From: [Avitabile, David](#)
To: ["Ndaw, Mamadou \(DCRA\)"](#)
Cc: ["LeGrant, Matt \(DCRA\)"; Epting, John; "Ilan Scharfstein"](#)
Subject: 2121 M Street (B1310607) - Response to Zoning Review Comments
Date: Sunday, November 10, 2013 12:32:25 PM
Attachments: [RE 2121 M Street -- Review of our discussion.msg](#)
[2121 M Street -- Review of our discussion.msg](#)
[Determination Ltr re 2109 M St to Epting 12-6-2010.pdf](#)
[At-Grade Connections.pdf](#)
[Valet Parking Plan.pdf](#)
[Hyatt Place M Street Rooftop Structures .pdf](#)
[Hyatt Place M St Site Plan - loading.pdf](#)

Zoning Comments for 2121 M ST NW - B1310607

Hyatt Place Hotel
2121 M Street, NW
Washington, D.C. 20036

1st FLOOR PLAN

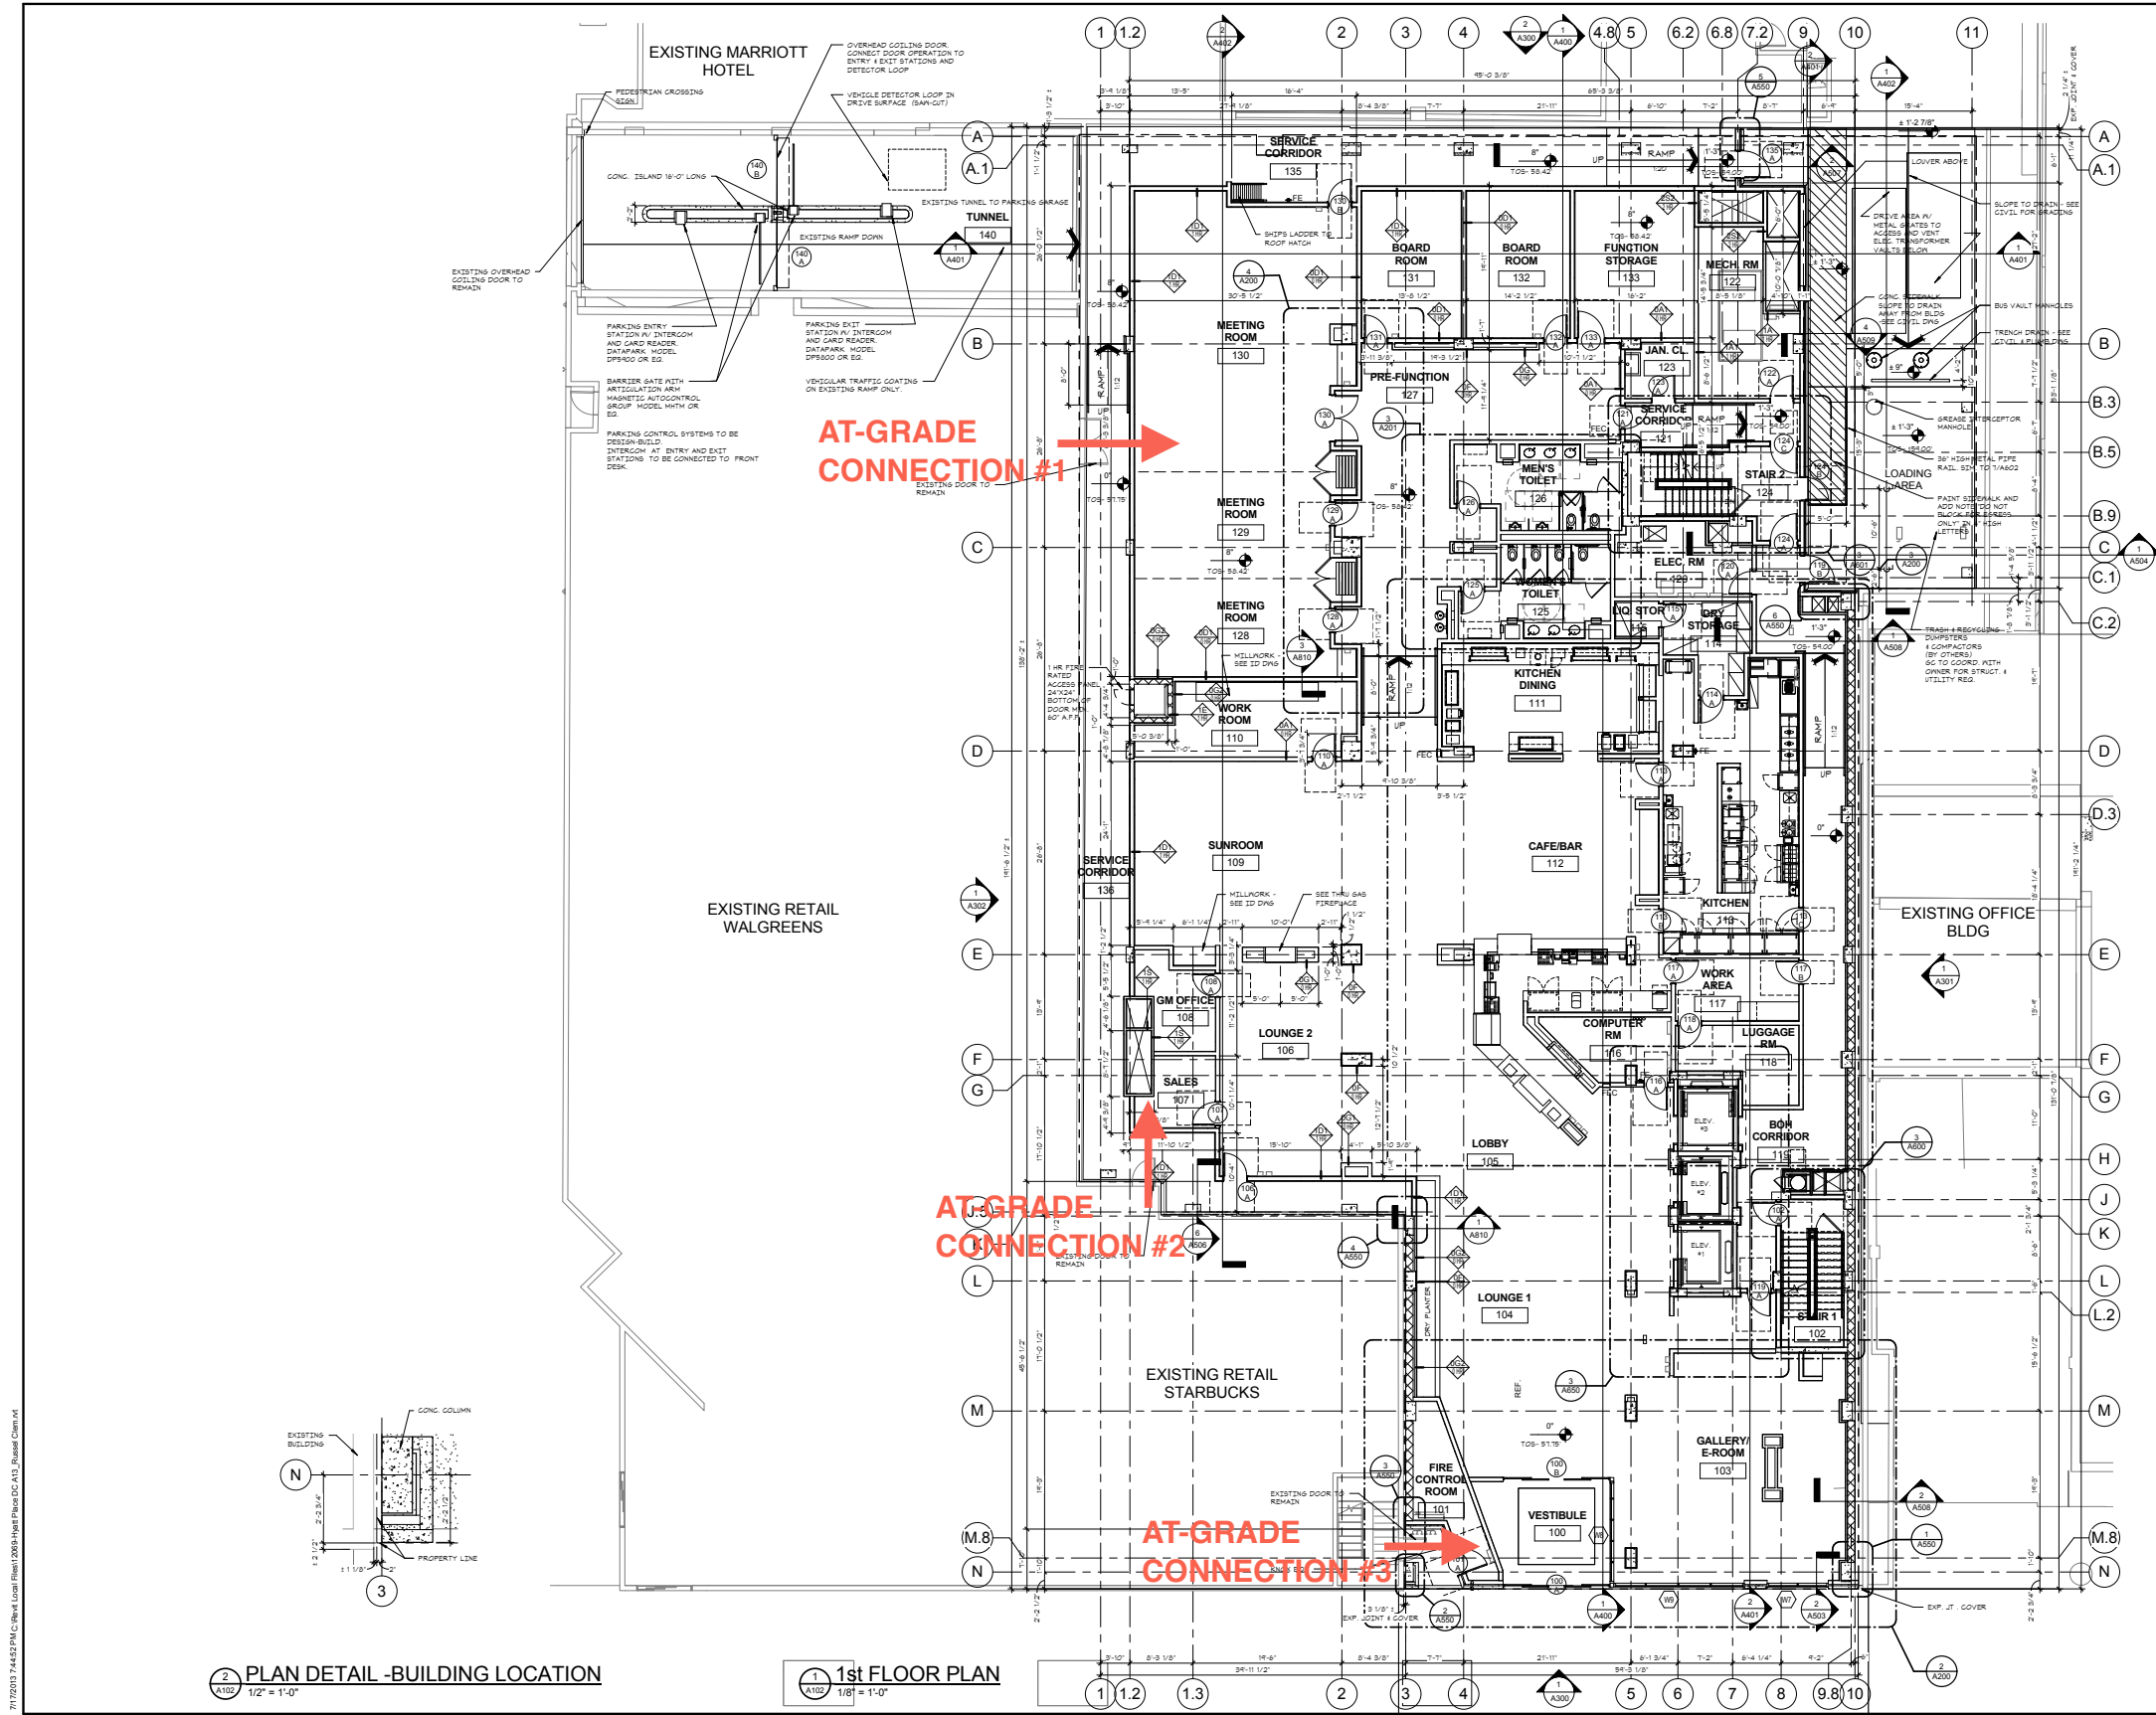
1. Please apply for a subdivision to convert the tax lot into a record lot. 2. Please explain what "addition to the existing Washington Marriott Hotel" means. Is the new hotel a separate entity from the Washington Marriott Hotel? If not please contact me by email before resubmitting the plans.

This was confirmed in our July 2013 meeting with Matt and is described in our August 2013 letter to Matt. Our property (Lot 880) is located on the same single record lot as the Washington Marriott and some ground floor retail establishments. Our Project will be connected to the other structures on the record lot through (a) the Marriott's hotel stair tower, which will exit into a vestibule within our building before discharging people out to M Street and (b) through doors at the rear of the retail spaces that provide access through and across a corridor on our parcel to the rear loading area and private alley. These connections are at street level and are therefore at or above the main floor of the structures. Accordingly, Matt confirmed the structures will constitute one building for zoning purposes. For your convenience, I've marked up the ground floor plan to call out the at-grade connections described above.

LOWER LEVEL 1
FLOOR PLAN

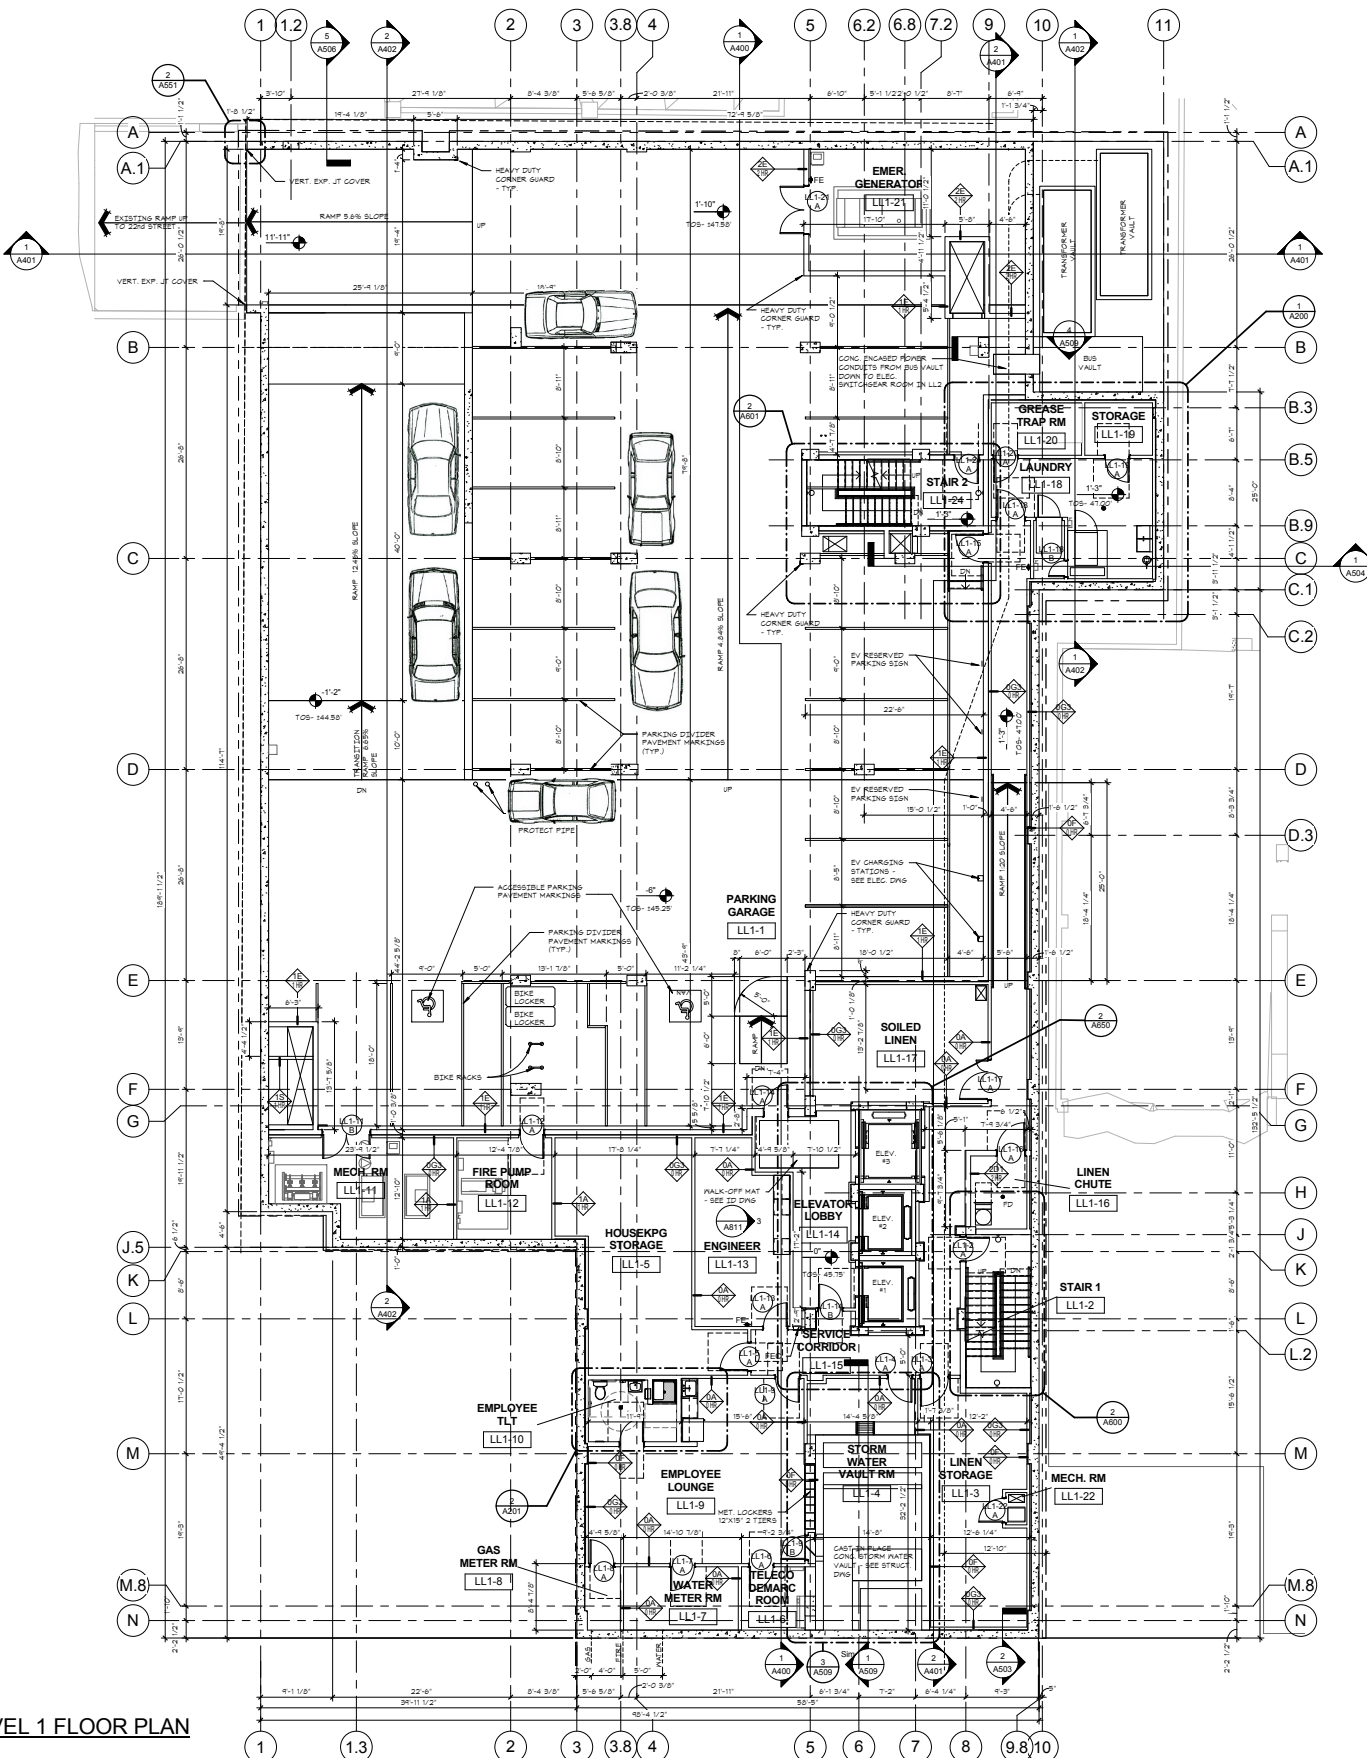
5. Please check for compliance with §2101.1; §2115 & §2117.4; number of parking spaces, minimum required dimensions for parking spaces, and access to required parking spaces.

6. Indicate the total number of bicycle spaces provided per §2119.2.

Section 2101.1: The building has 168 rooms and a 1,710 s.f. function room, for a total parking requirement of 48 spaces (1 per 4 rooms and 1 per 300 s.f. of the largest function room space). We are going to exercise our prerogative under Section 2115.9 to use valet parking to meet our parking requirement. With valet operations, we can provide all 48 spaces within our garage. See attached valet parking plan.

Section 2117.4: Good question. As is noted on the Lower level 1 plan of the Valet parking plan, our parking garage is accessed directly from 22nd Street via an unobstructed private drive that runs under the existing Washington Marriott to our garage. The ramp exists now; we just need to connect to it. We have provided a plan that shows the required loading spaces; the architects have also shown the location of the ramp.

Per Section 2119.1, bike parking is only required for office, retail or service uses in certain zones. We're a hotel, so no bike parking is required. That said, we provide six bike parking spaces on the Lower Level 1 of the building (they are shown on the attached Valet Parking Plan as well). That's 12.5% of our required 48 parking spaces, so well in excess of the 5% requirement.

ARCHITECTURAL
SITE PLAN

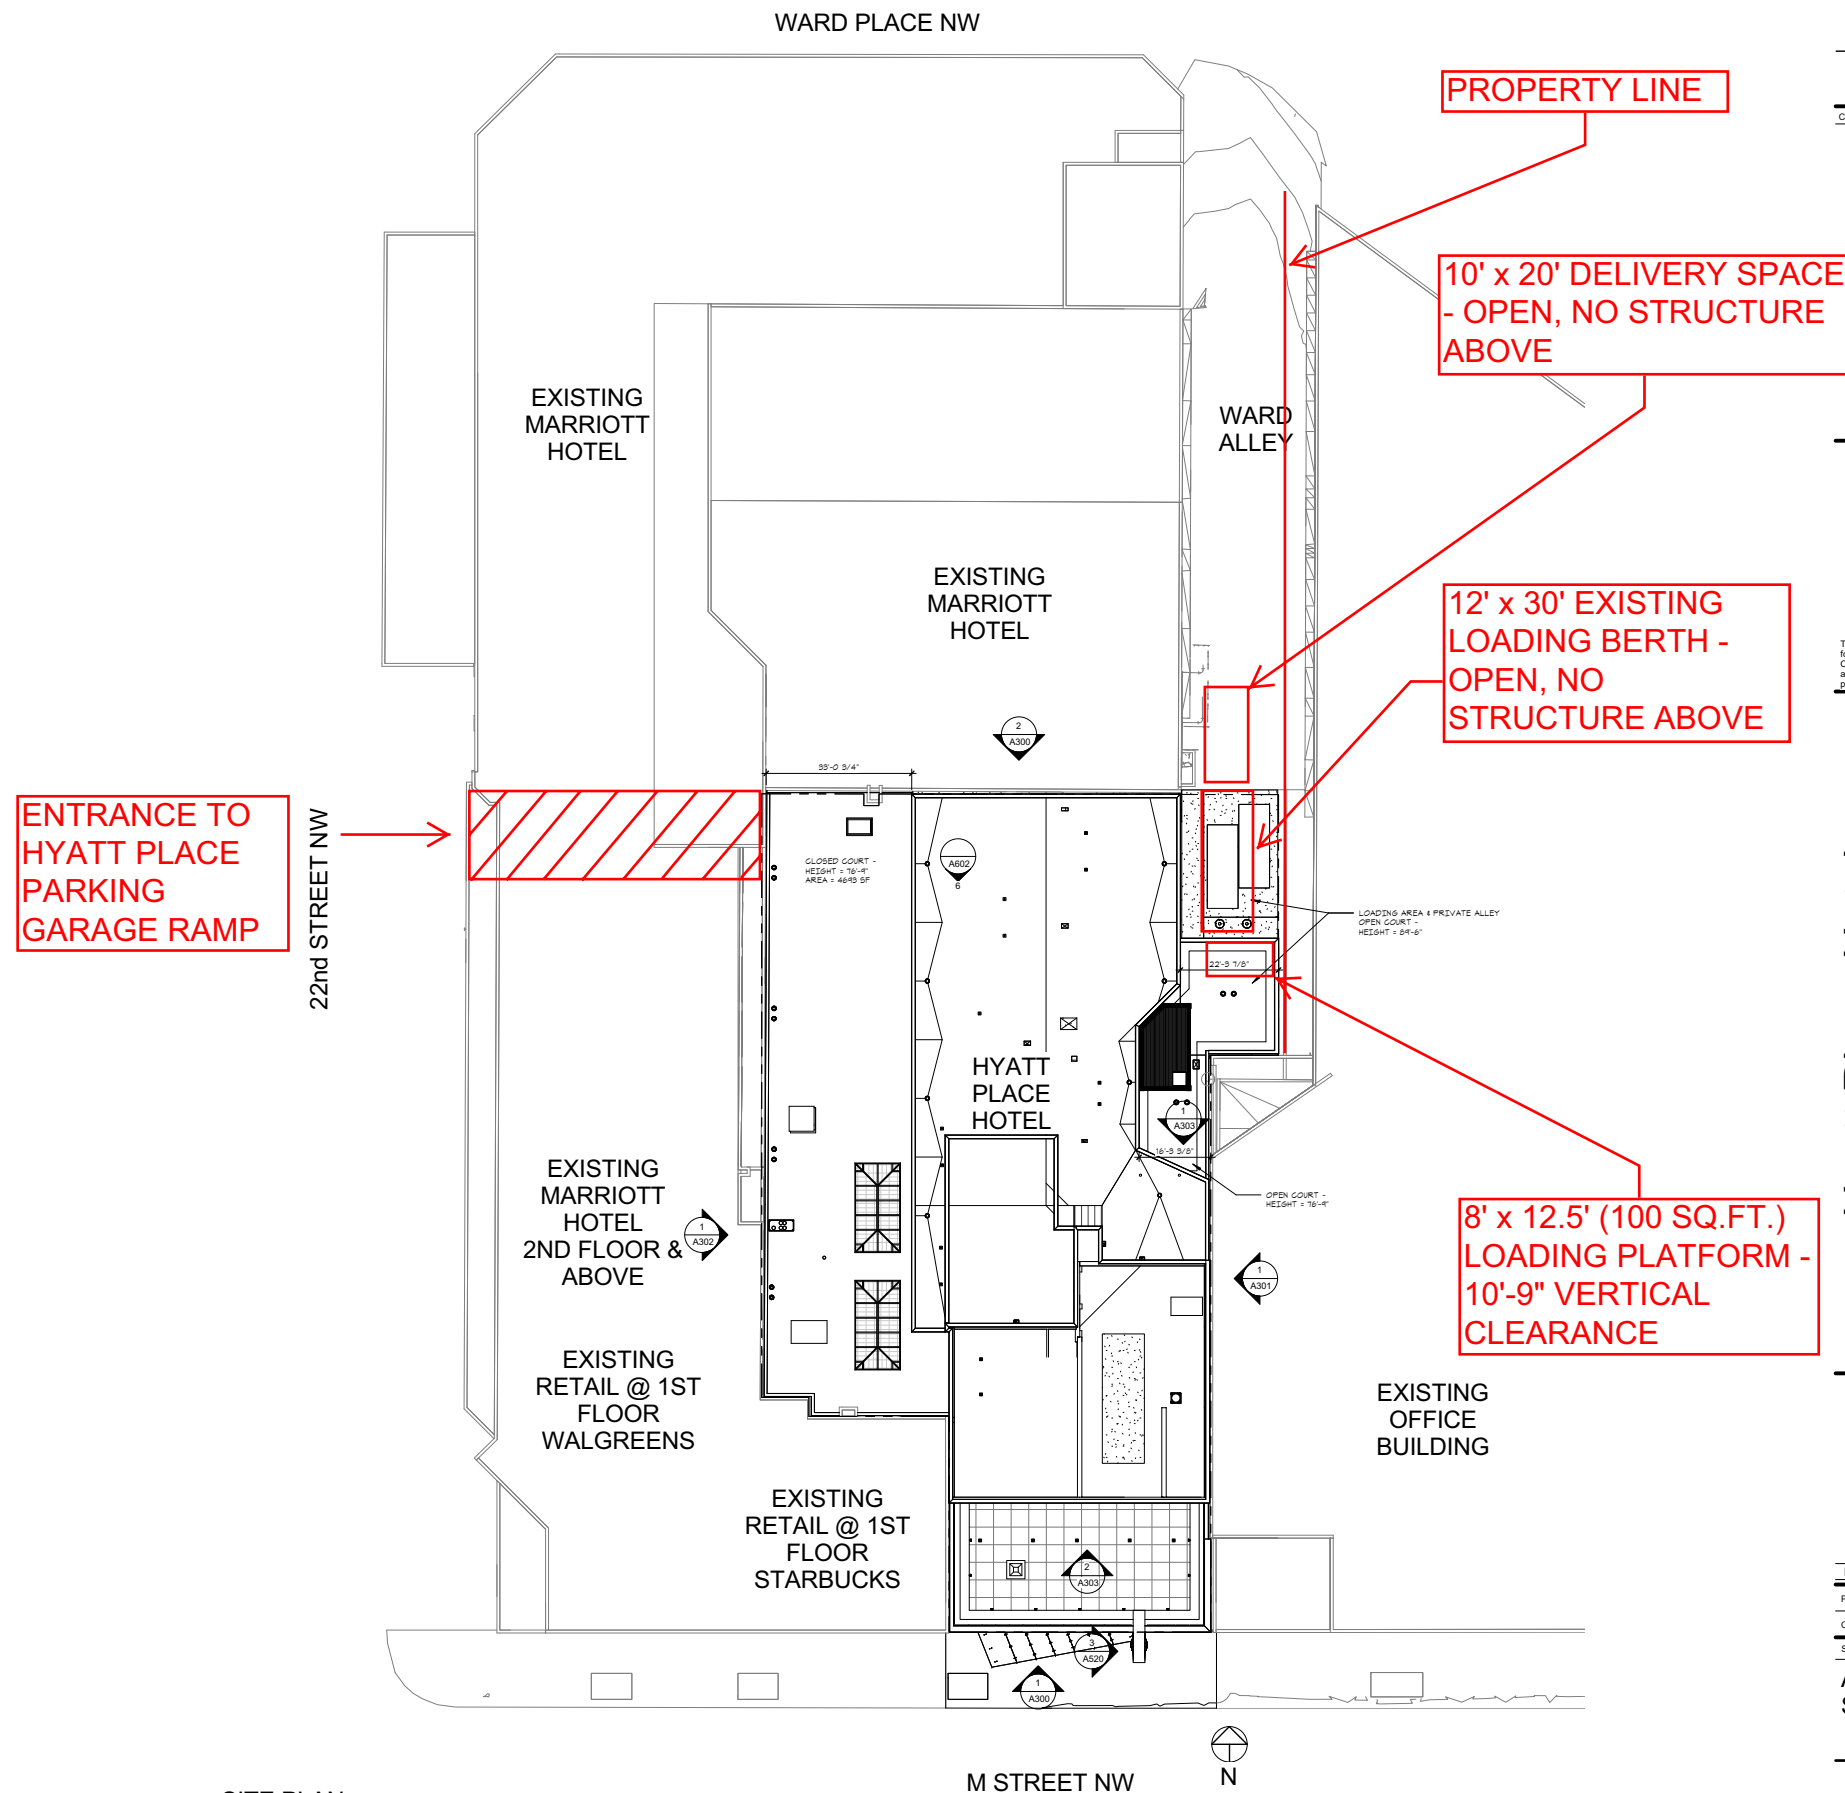
7. Please clearly identify and dimension on the site or floor plans, the loading berth, loading platform and service/delivery spaces. Please comply with minimum vertical clearance for loading berths per §2201.6 and §2204.2 access to loading berth, platform, etc.

Attached is an exhibit that shows the required loading. As Mr. Le Grant confirmed both in Dec. 2010 and again in July 2013, the loading can be provided anywhere on the record lot. Here, the 30-foot loading berth is in our loading area adjacent to the loading platform, and the 20-foot space is further back in the private alley.

Section 2201.6: the berth is open to the sky and therefore meets the minimum vertical clearance of 14 feet.

Section 2204.2: the berth and space are both accessible from Ward Place via a private alley.
